# **CONNECTION ASSESSMENT & APPROVAL PROCESS**

*Project: MacKay TS - Replace breakers & disconnect switches*

***CAA ID No. 2002-EX050***

#### *Replace 115kV breakers & disconnect switches*

**DIAGRAM 1**

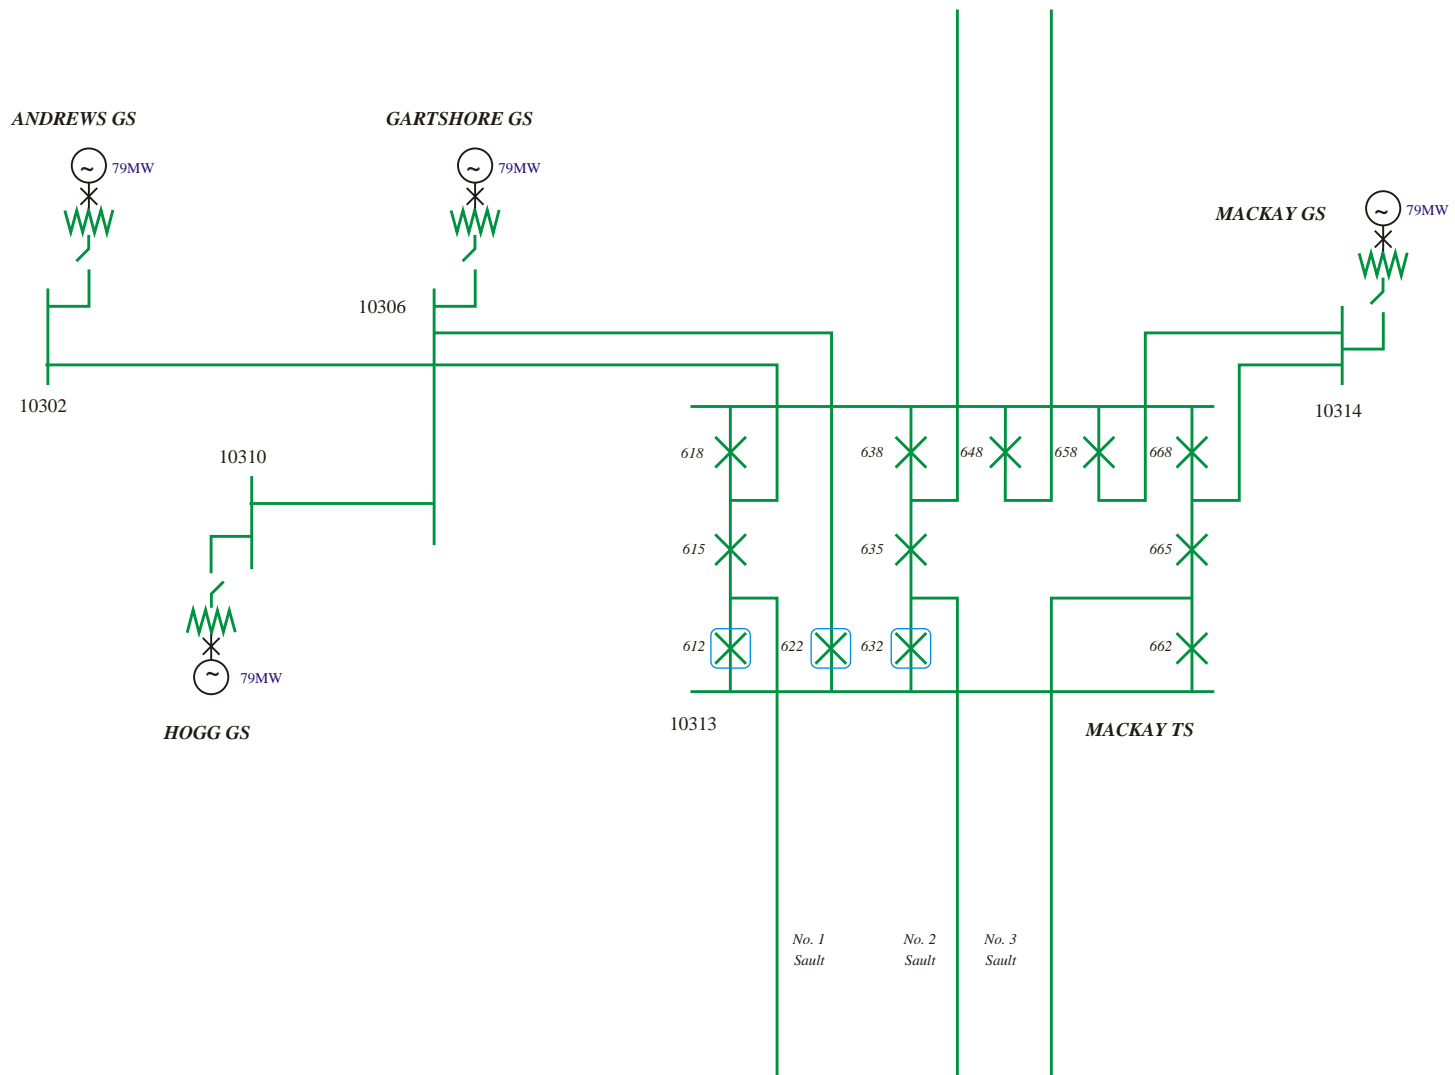
The facilities that are to be replaced are shown in Diagram 1.

It should be noted, however, that the three replacement breakers will not comply with the Transmission System Code that requires a rating of 50kA for new 115kV breakers.

While the 40kA rating of the new breakers is expected to be adequate for all foreseeable developments on the GLP system, should a third party initiate a development that would result in the fault level increasing above 40kA, then the subsequent replacement of these three breakers would be expected to be undertaken at Great Lake Power's expense.

breakers that are to be replaced  
 (Includes the associated disconnect switches)

It is therefore recommended that a Notification of Approval of the Connection Proposal be issued.
